JAMES DICK CONSTRUCTION LIMITED

**RE: Zoning By-Law Application 09/12
Hidden Quarry: Part Lot 1, Concession 6, Township of Guelph/Eramosa,
County of Wellington**

| # | Contact | Date | Question | Response | Action Item | Who |

Figure 4:
Downgradient Private Wells

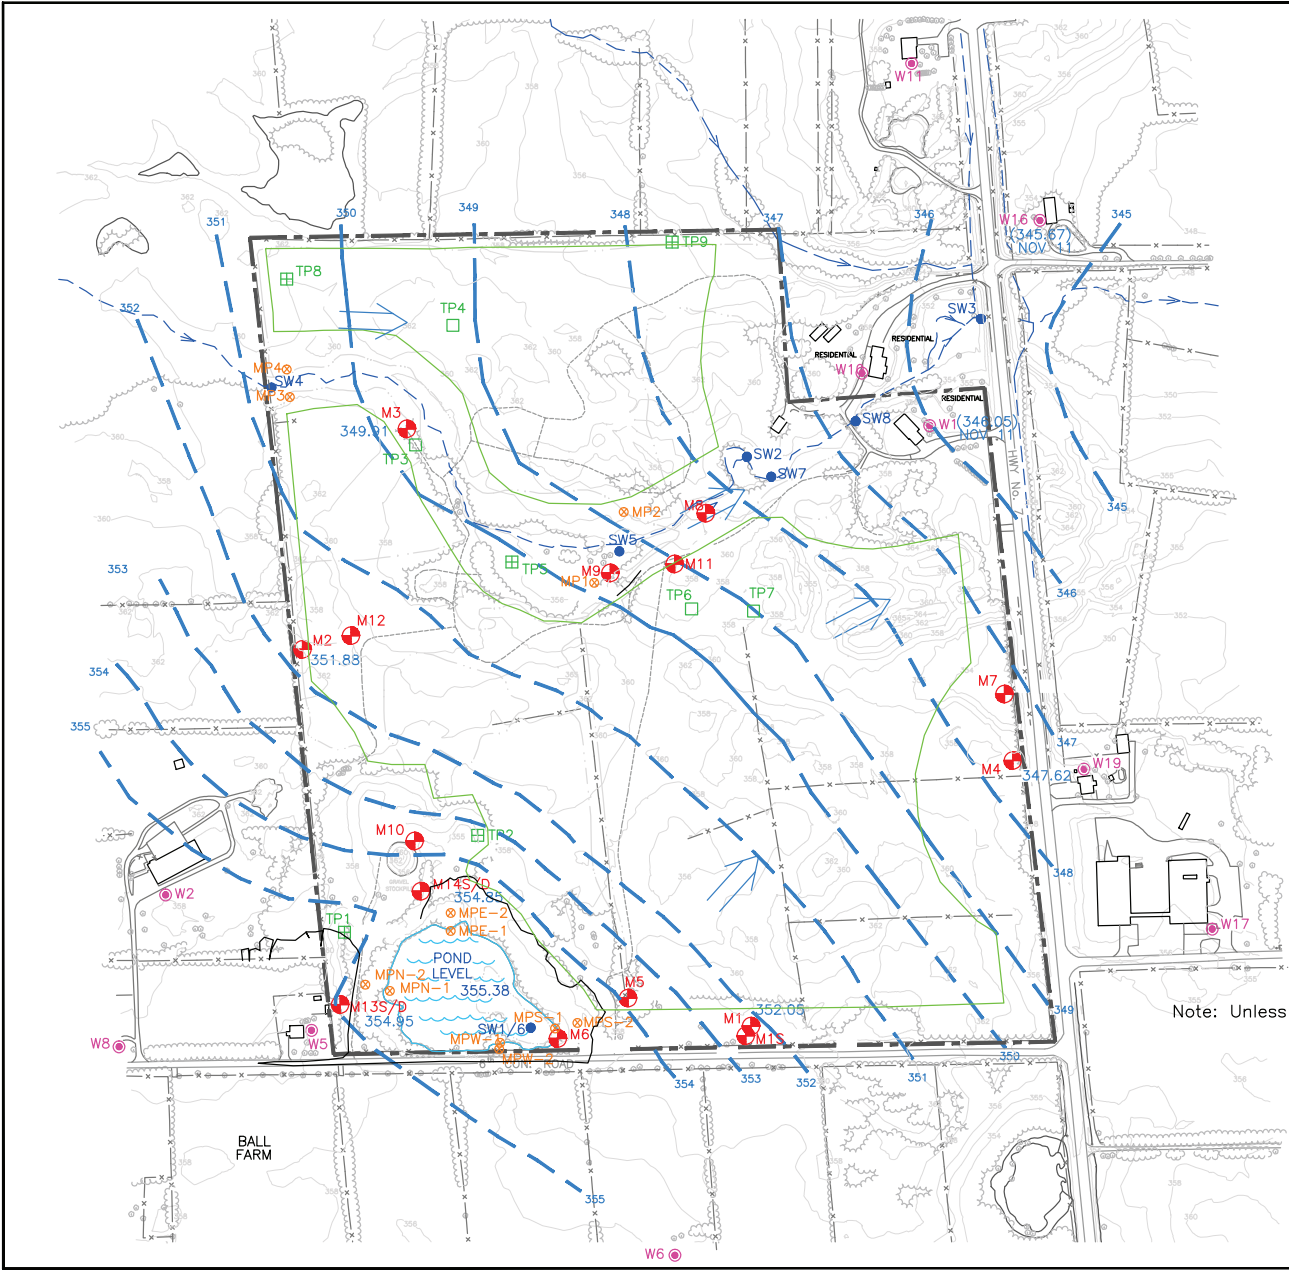
| 4 | Region Halton | 28-Jul-14 | <p>Domestic Wells:</p> <ul style="list-style-type: none"> Little is known of the current status of private wells in Halton Region south of Hwy 7 as the last well survey was conducted in mid-1990s. Both a survey and well assessment should be carried on all wells in Halton Region potentially under the influence of the flow from the quarry site. At a minimum, all properties that lie within the 500m zone should be subject to a well survey, including wells at these properties that might be located somewhat outside of the 500m zone. | Agreed. Please see Response #3 above. Also please find attached a figure entitled "Down Gradient Wells" that illustrates the four wells in Halton Region that are down gradient from the quarry. All of these wells have been included in the Voluntary Well Survey. Please also know that with the reduction in quarry depth, there remains considerable rock left in situ beneath the quarry to allow for groundwater to continue to underflow the Quarry in undisturbed fracture sets. This allows the opportunity to retrofit downgradient wells to access this lower area of the dolostone aquifer. In the Harden June 10, 2014 correspondence to Burnside, James Dick Construction Limited agreed to the following proactive approach, subject to the request of the landowner. Pro-active modifications or retrofitting of these down gradient wells such that they are only taking water from the deeper fracture sets will be undertaken at the request of the landowner. Out of an abundance of caution we have also recommended that at-source domestic UV treatment systems be installed at the downgradient wells. UV systems should be in place in this fractured bedrock environment area in any event even without a quarry. All modifications will be done at no cost to the landowners. With these measures in place it is Harden's opinion that there will remain access to abundant high quality domestic water supplies at all receptors. | Attach June 10, 2014 Letter and Figures. Also attach Figure 4 Dec 2013 "Down Gradient Wells". | JDCL |

|  HARDEN Harden Environmental Services Ltd. | Project No: 9506 | Hydrogeologic Impact Assessment Proposed Aggregate Extraction | Figure 6.1: Proposed Pre Quarry Well Survey Locations |

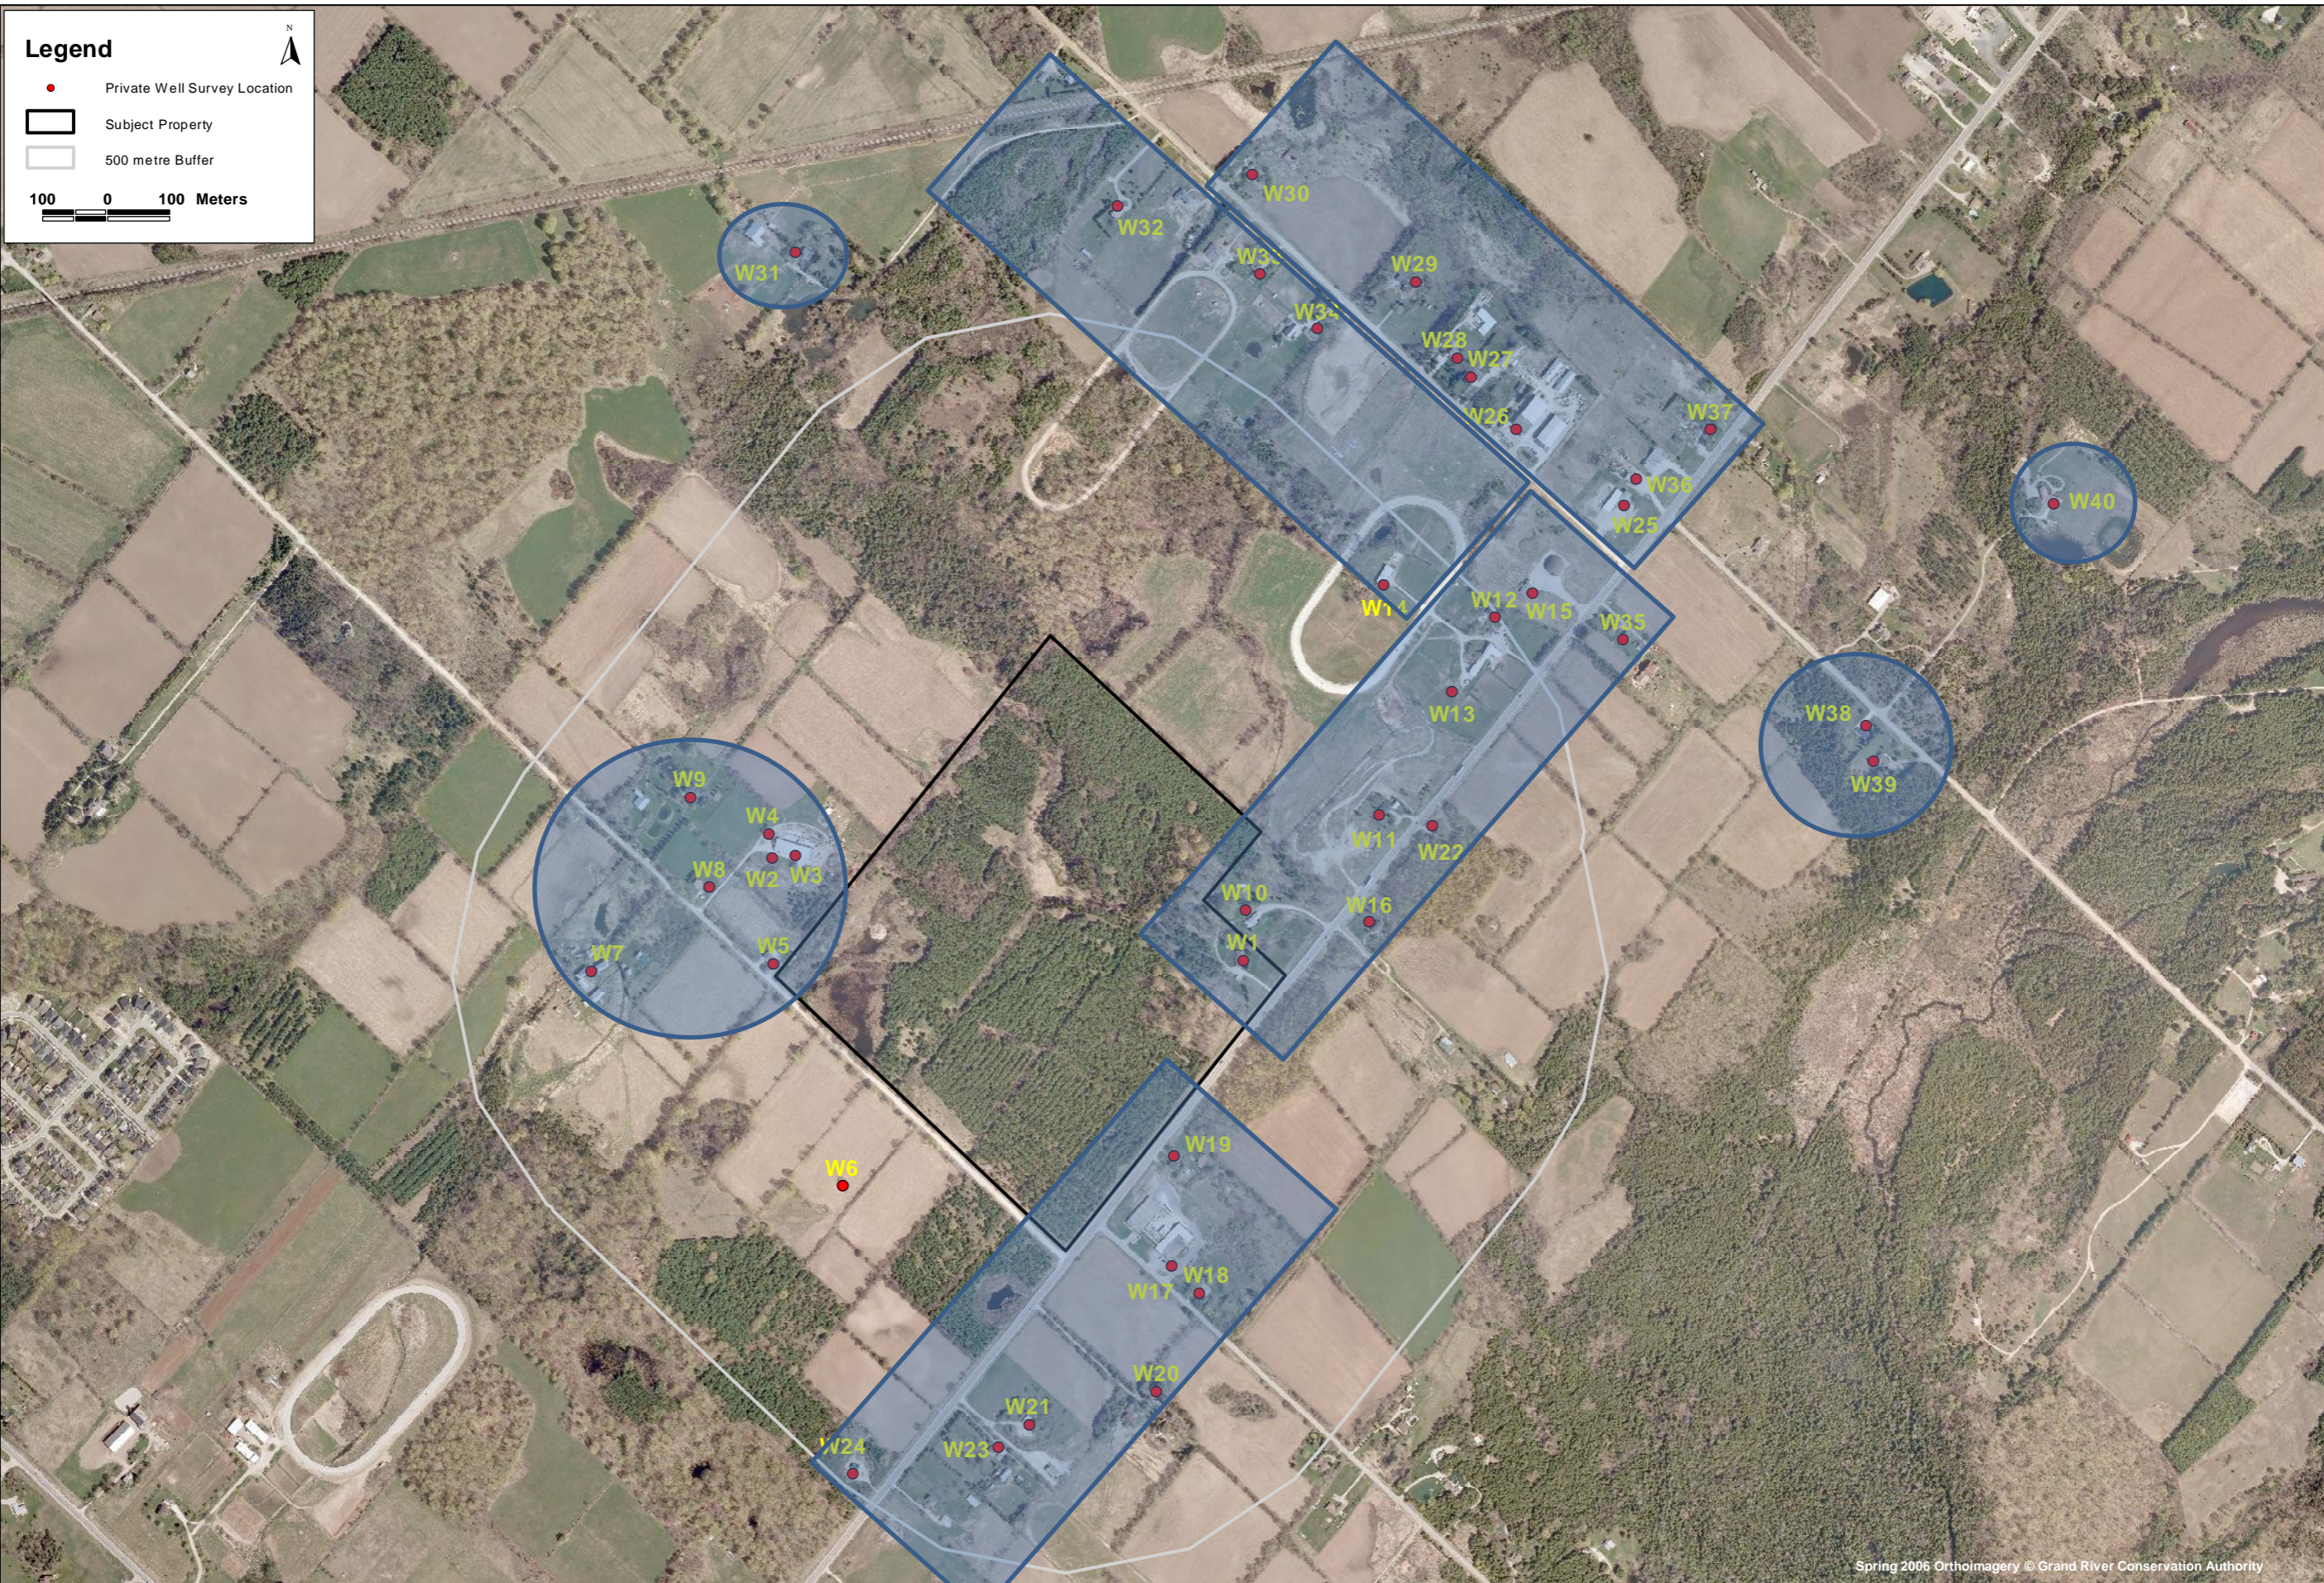
| 3 | Region Halton | 28-Jul-14 | <p>Groundwater Levels:</p> <ul style="list-style-type: none"> In their November 12, 2013 correspondence, Burnside indicated that there is significant potential for impacts from the proposed quarry activities on the groundwater resources in the surrounding area. This correspondence recommended, among other things, that all domestic wells within 500m of the quarry site be inspected and tested to evaluate how susceptible they are to water level variations, and that the proposed monitoring program should be expanded to include representative domestic wells. The groundwater levels and temperature monitoring at the south side of the subject lands should be expanded beyond M4, to all accessible domestic wells south of Hwy 7, as noted below. | James Dick Construction Ltd. has agreed to undertake a voluntary detailed well inventory and water quality assessment of wells within 500 m of the quarry, for residents who consent to give access to their wells for this purpose. This will be conducted to establish baseline water quality and quantity conditions. Harden Environmental has already undertaken three such studies as summarized in attached Table 9 and Figure 10. Since 1995, Harden has surveyed forty local residents and has on at least one occasion, visited every residence within 500 metres of the quarry. James Dick Construction Ltd. has agreed to upgrade wells, those in pits or buried, to facilitate water level monitoring of up-gradient wells, if agreed to by the home owner. Based on previous surveys, this will include wells W5, W8 and possibly W7. Down-gradient wells and those distant from the quarry are not expected to experience any significant water level change or will likely see a small increase in water level. Water quality samples can be obtained from the existing plumbing system. Residents at locations W25 to W30 and W36 to W40 (W38,39 and 40 located in Halton Region) will be asked if they are willing to participate in the voluntary baseline monitoring program. These wells are beyond the 500 metre distance and unlikely to be impacted by the quarry. However, a one-time baseline survey will be conducted. There will be a minimum period of two years after the quarry is given approval before below-water-table extraction can commence. This provides ample opportunity to obtain seasonal water quality data as recommended by Burnside and Associates. | Attach June 10, 2014 Letter and Figures. Attach modified Figure 6.1 Well Survey Locations Figure. | JDCL |

| 12 | Region Halton | 28-Jul-14 | Private Well Monitoring: We note that the Harden Environmental February 5, 2014 letter indicates that a well monitoring program for water quality and an action plan to remedy any issues is proposed to protect neighbouring private wells. It is not clear to Regional Staff how this program protects or addresses private wells within the Region of Halton. Further, it is not clear to Regional Staff that all private wells in close proximity to the extraction site have been evaluated or are included in this program. | Please see attached Modified Figure 6.1 illustrating all wells located within the 500m Well Survey Zone. These wells include private wells located in the Region of Halton, specifically the Town of Milton. | Attach June 10, 2014 Letter and Figures 6.1. | JDCL |
